Planned Development Major Amendment Staff Report

Date: November 18, 2025
To: Douglas County Planning Commission
From: Brett Thomas, AICP, Chief Planner *BT*
Curtis J. Weitkunat, AICP, Long Range Planning Manager *CW*
Steven E. Koster, AICP, Assistant Director of Planning Services *SK*
Subject: Sterling Ranch Planned Development, 14th Amendment
Project File: ZR2025-012

**SUBJECT: STERLING RANCH PLANNED DEVELOPMENT - 14TH AMENDMENT
MAJOR AMENDMENT APPLICATION**

Land Use Plan Overview

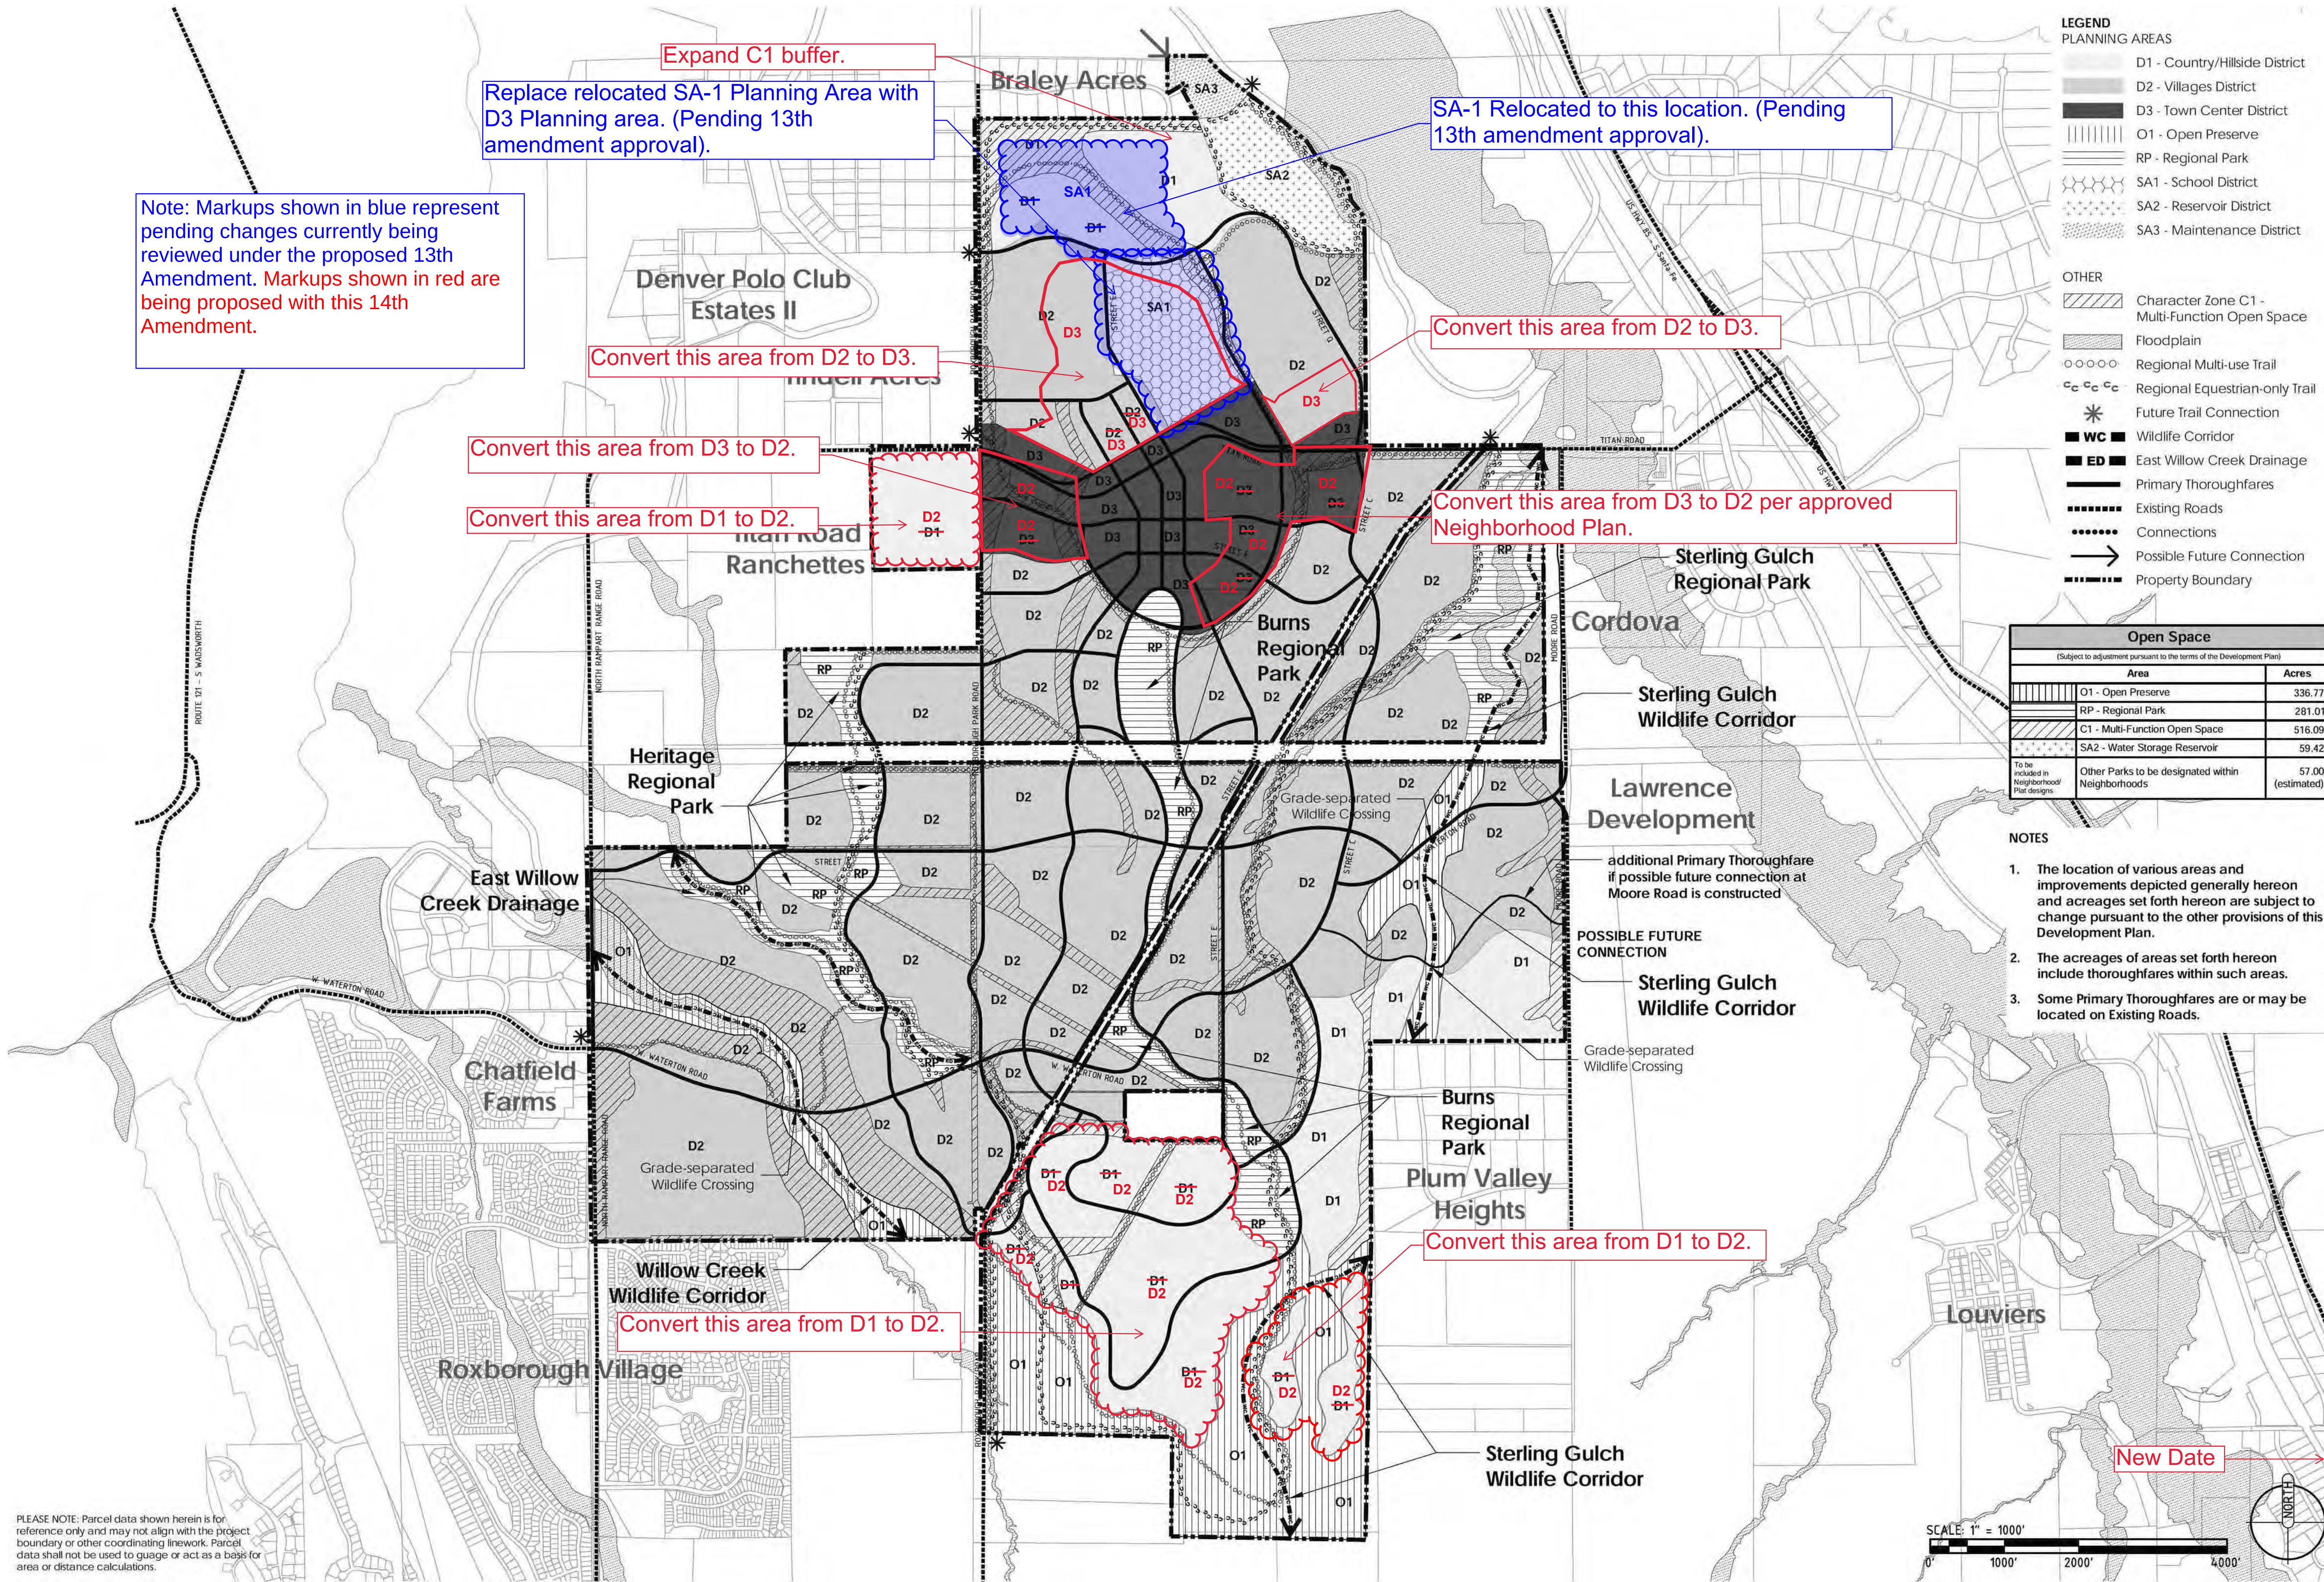
Expand C1 buffer.
Replace relocated SA-1 Planning Area with D3 Planning area. (Pending 13th amendment approval).

Convert this area from D3 to D2 per approved Neighborhood Plan.

Plan Detail B

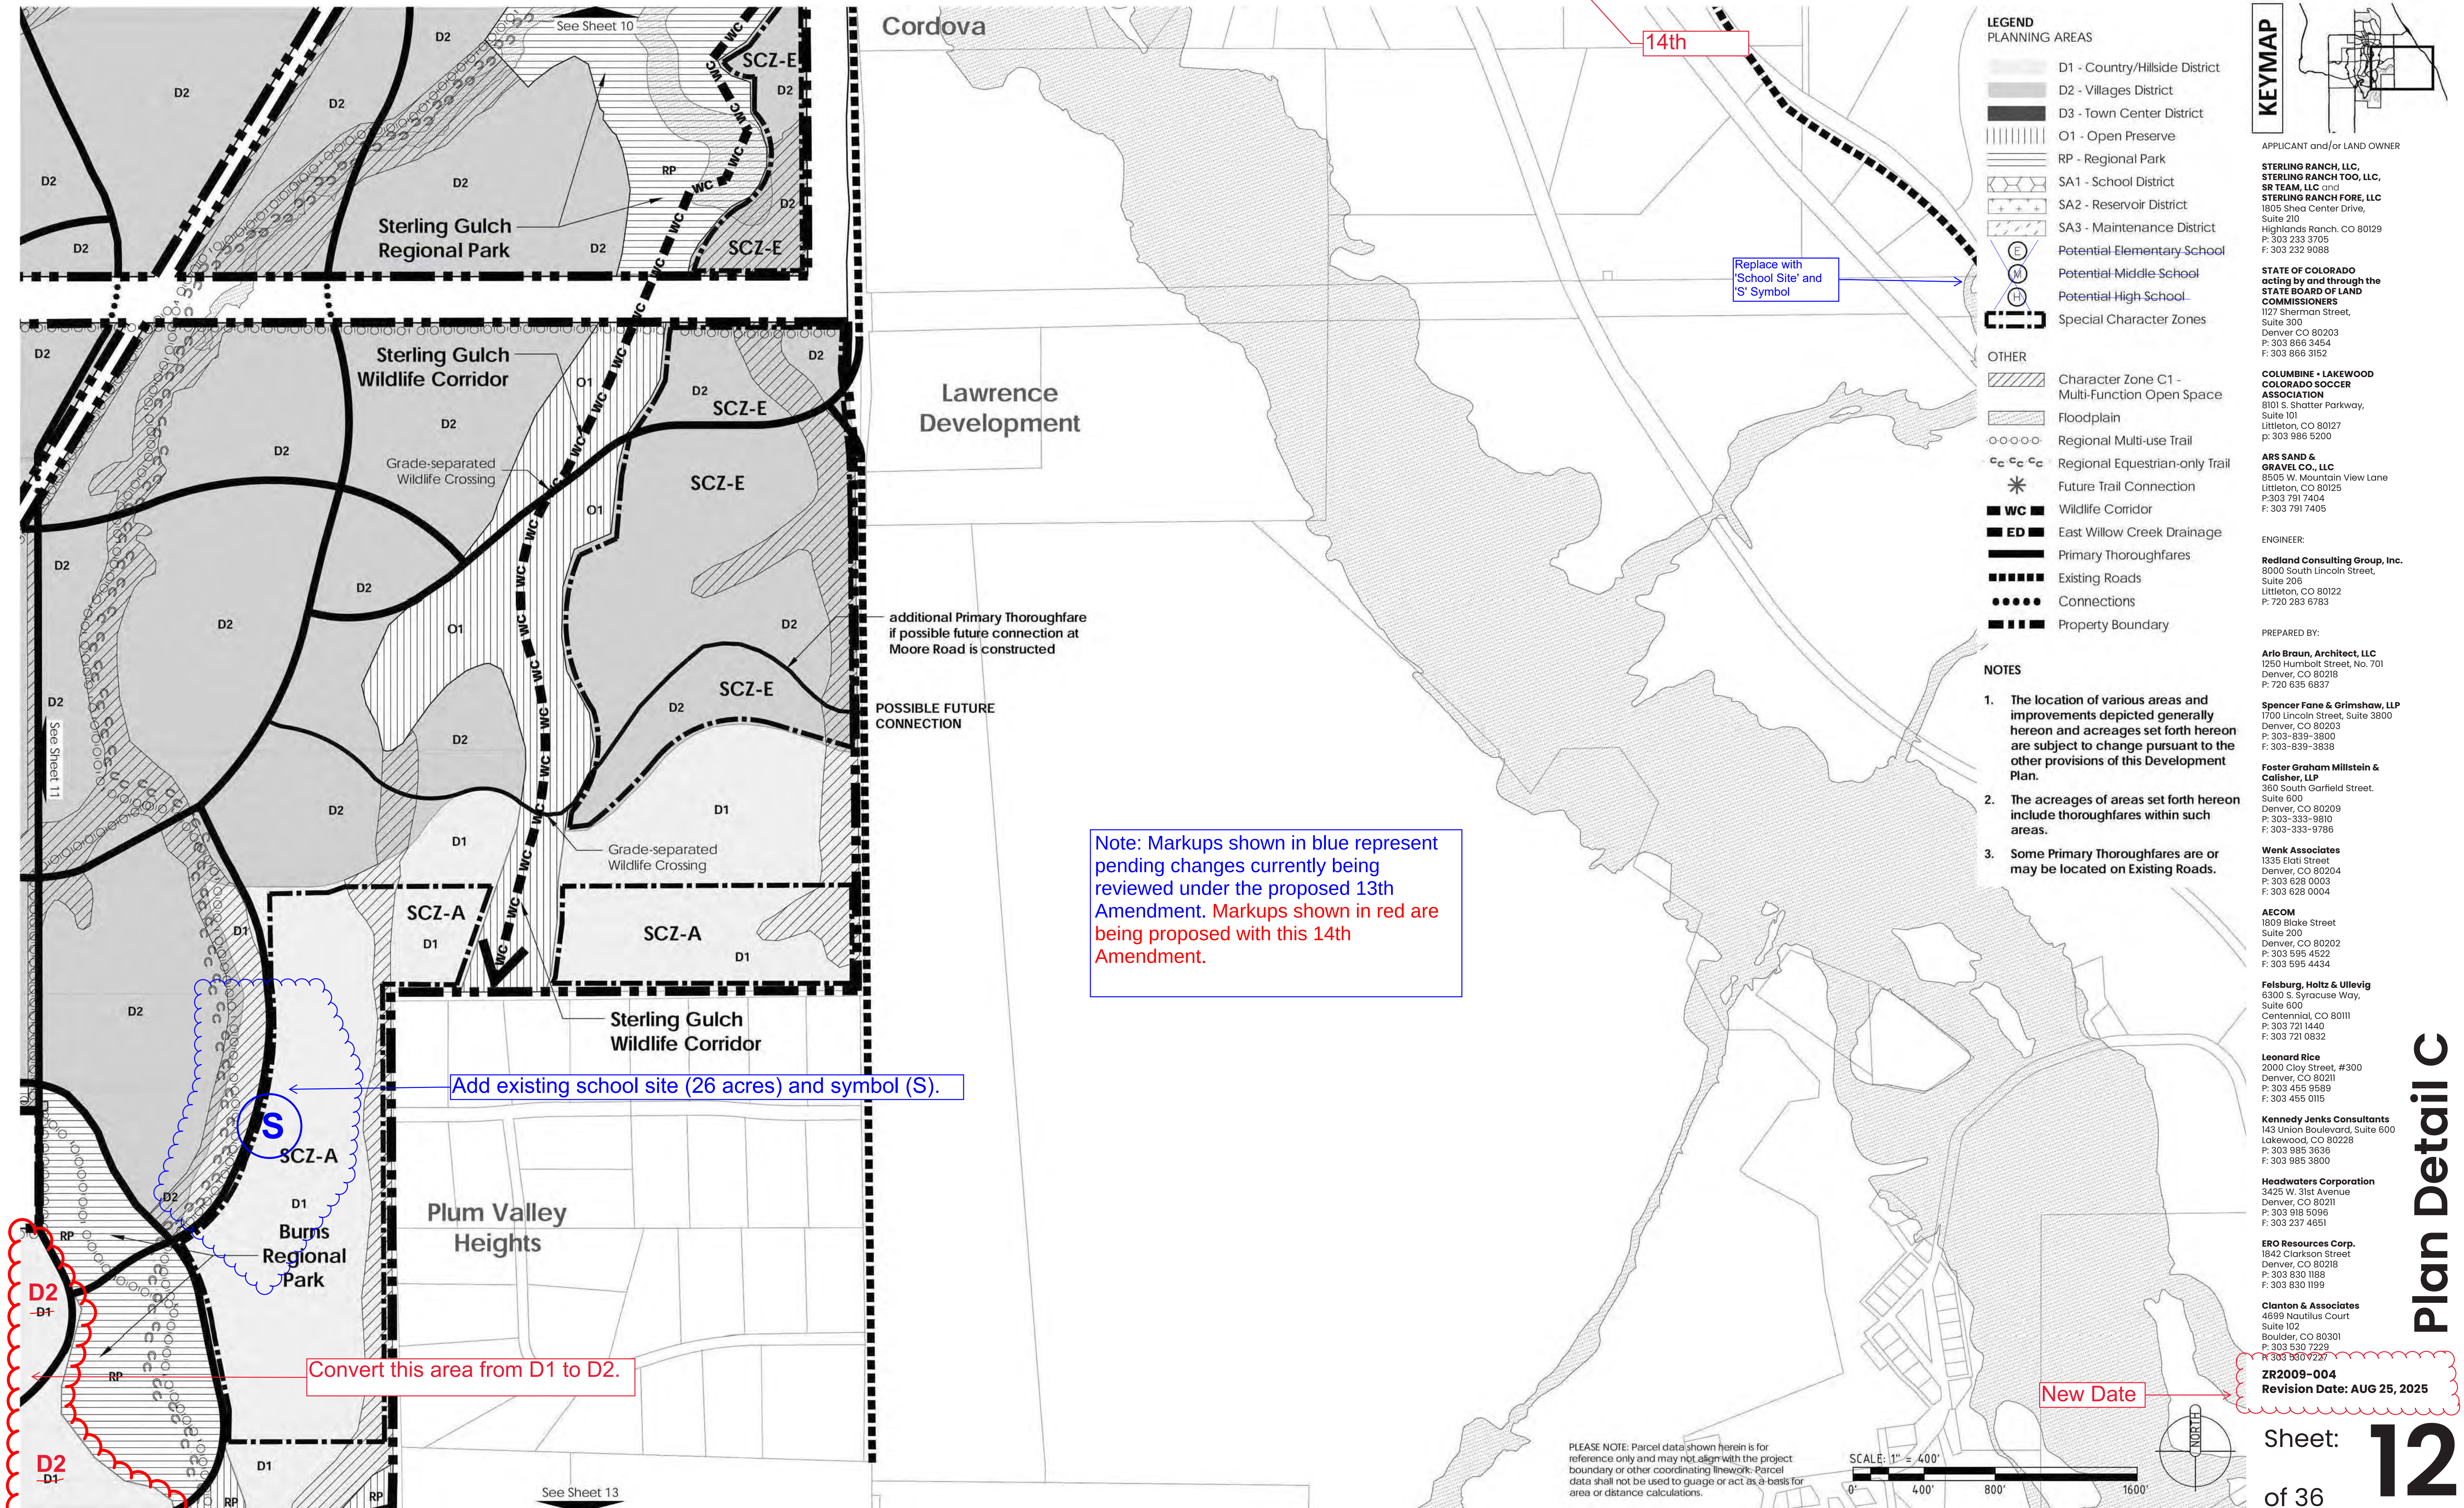
Replace with 'School Site' and 'S' Symbol

Table 17.1

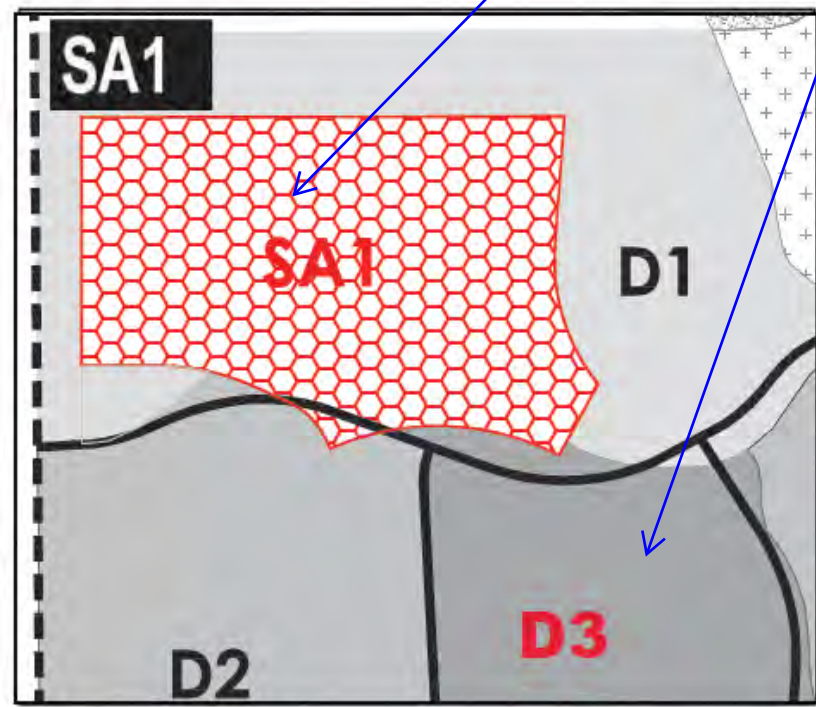
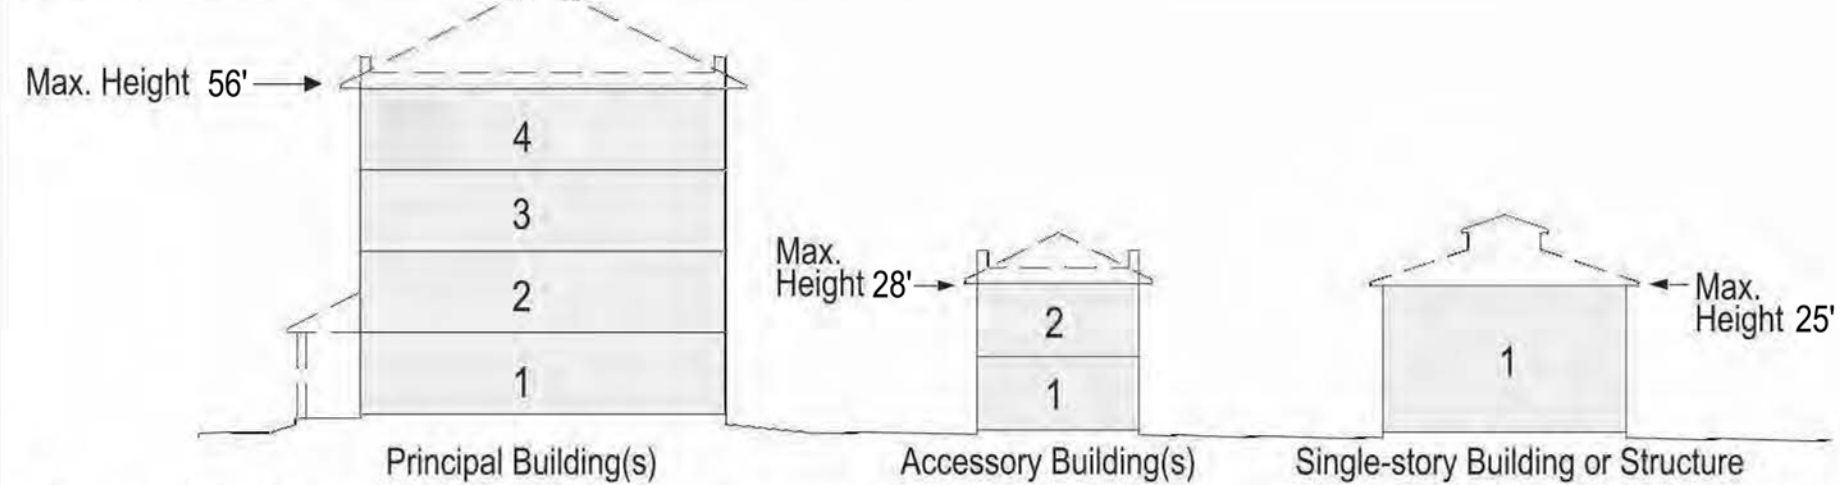
Show relocated SA1 site.

Show D3 and D2 Planning Area in Place of former SA1 Planning Area.
